Newtonville Area Council

Austin Street Parking Lot Development Presentation

Public Hearing – June 9, 2015

2014 vs. 2015 Evening Parking

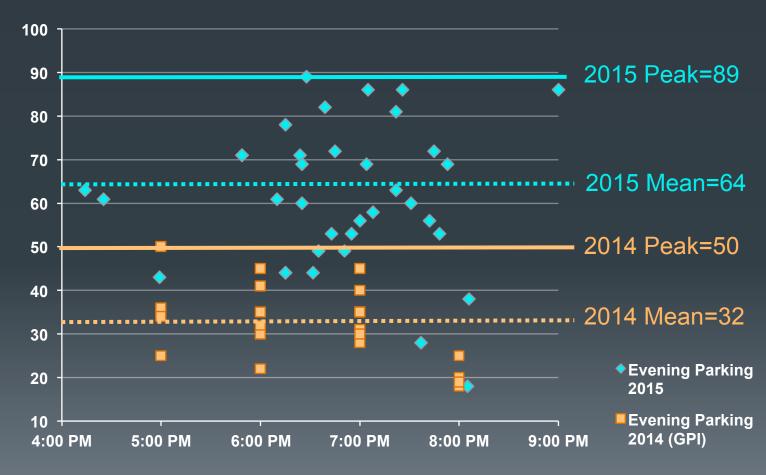
Mean demand doubled

2015 data comprise 42 random sample points collected March – May 2015 by Thomas Kraus

Current Proposal

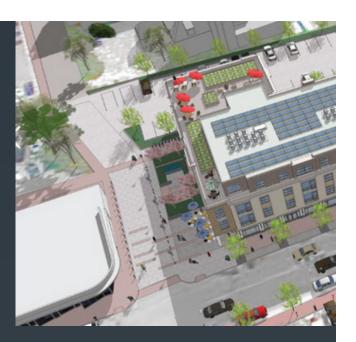
Good:

- Well located
- Attractively paved, greenery, fountain

Suggestions:

- Central location for fountain
- Ensure abundant public seating
- Consider eliminating car traffic on northern portion of Bram Way
